Product Change Notice

Issue Date: 1st July-2021

Introduction of replacement die for below part numbers.

Figure 1

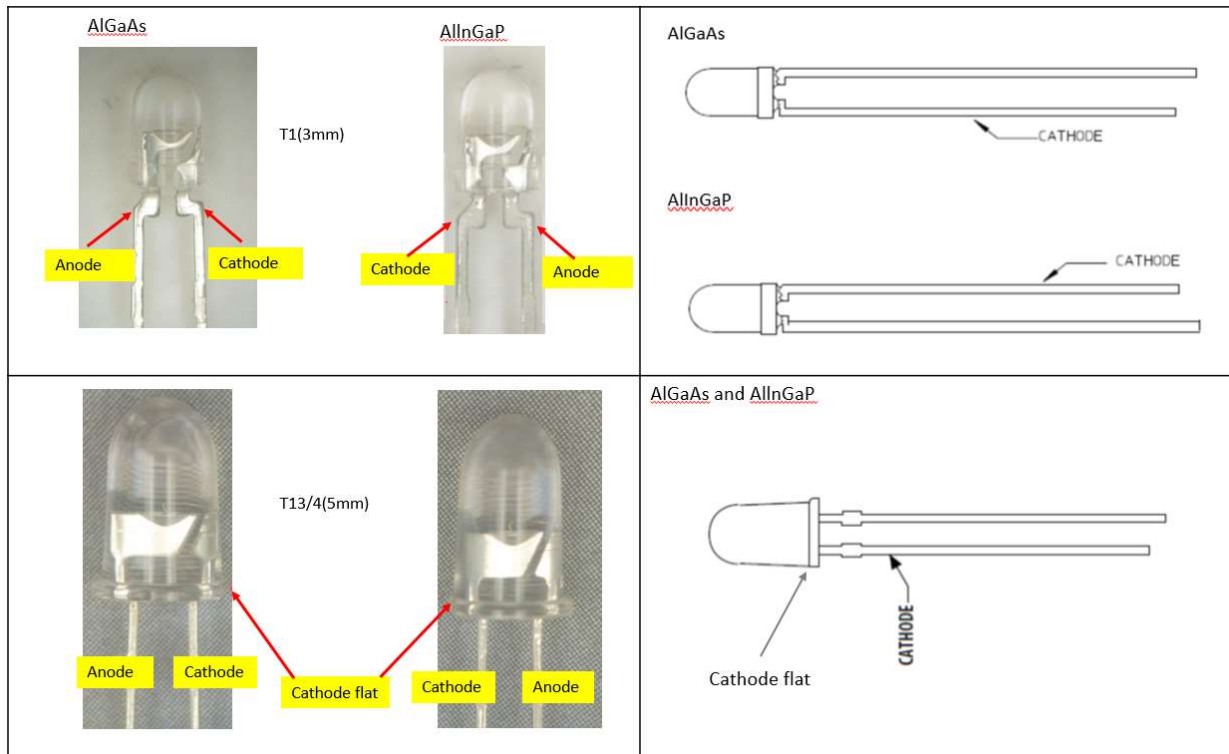
Group 2 (AlGaAs LED Lamps) will have a change in form as shown in Figure 1.

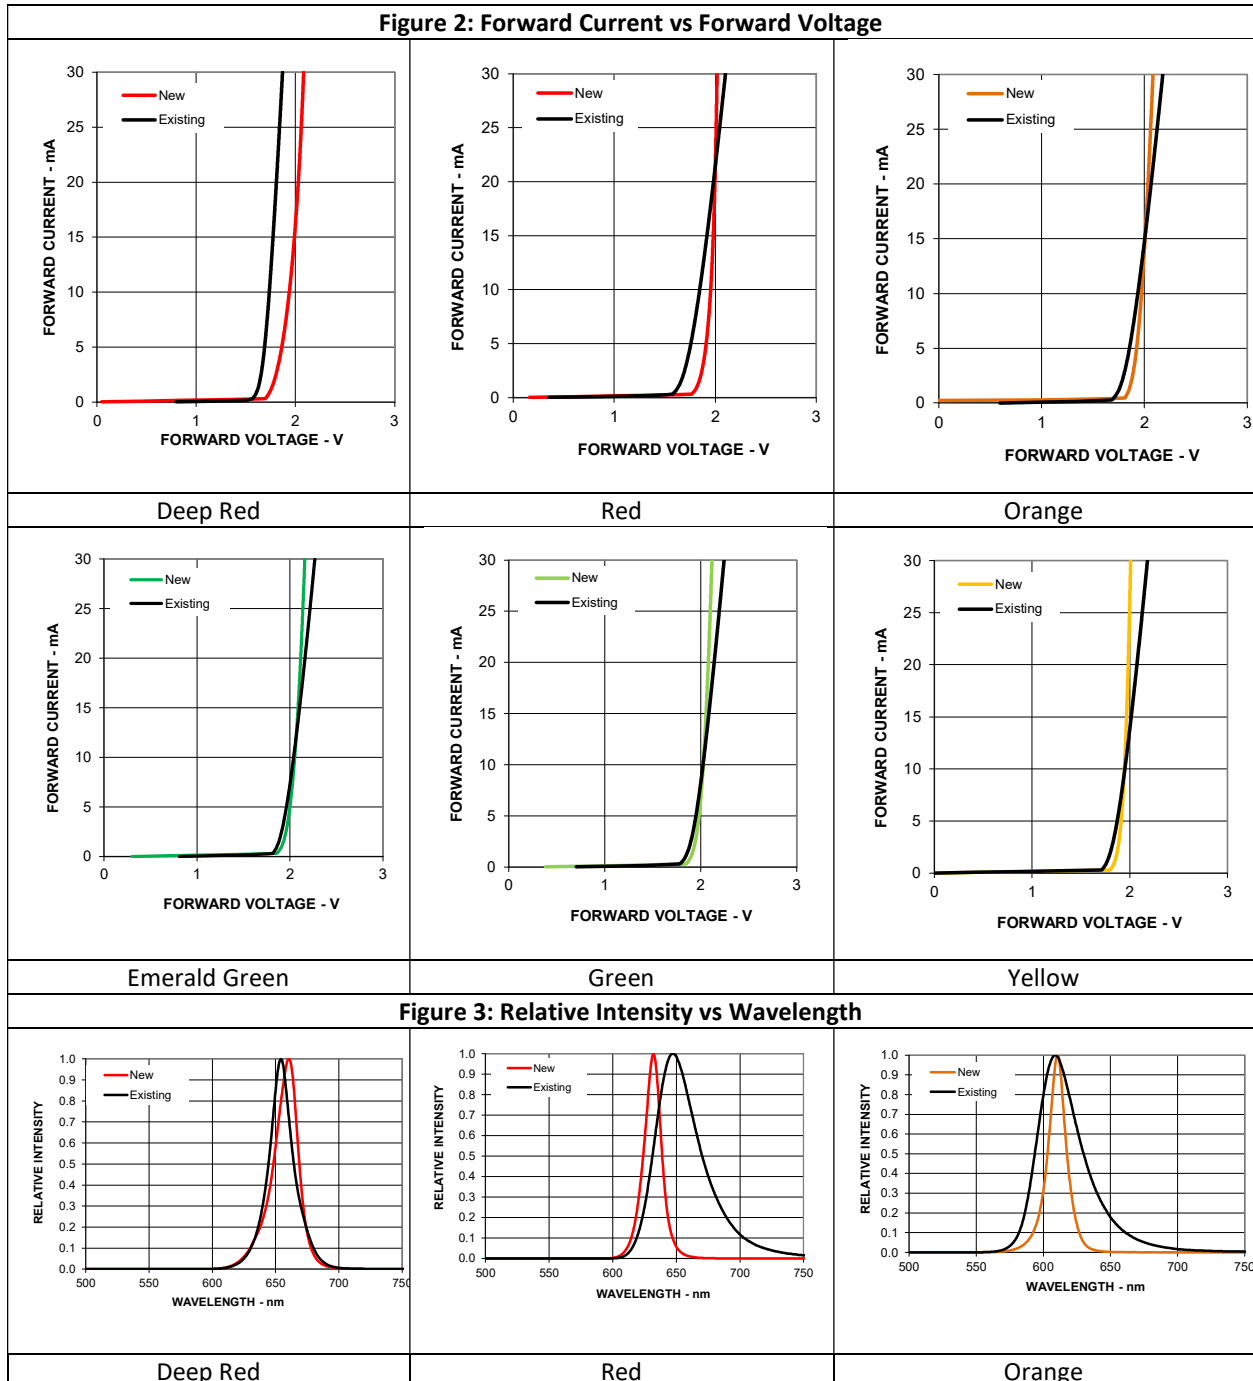
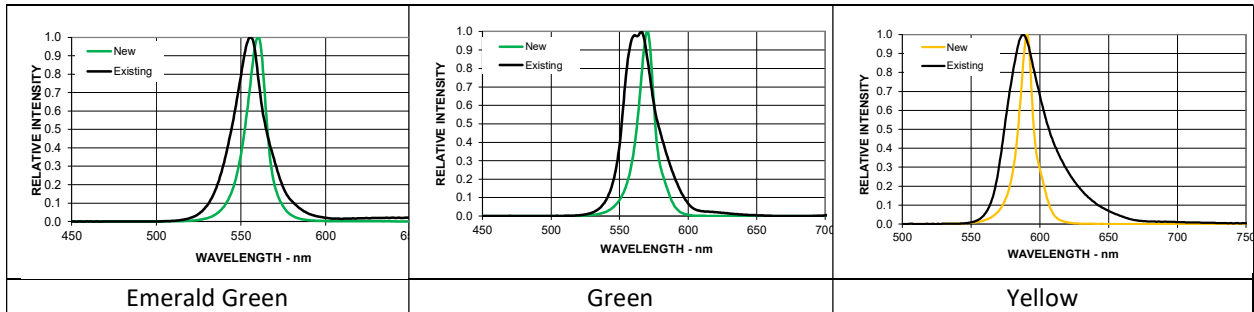
Following are the changes in product characteristic for both Group 1 and 2 of the LEDs.

1. Forward Current vs Forward Voltage.
2. Relative Intensity vs Wavelength
3. Relative Intensity vs Forward Current
4. Luminous Intensity : Some part numbers will experience higher typical intensity (refer to individual datasheet for details)
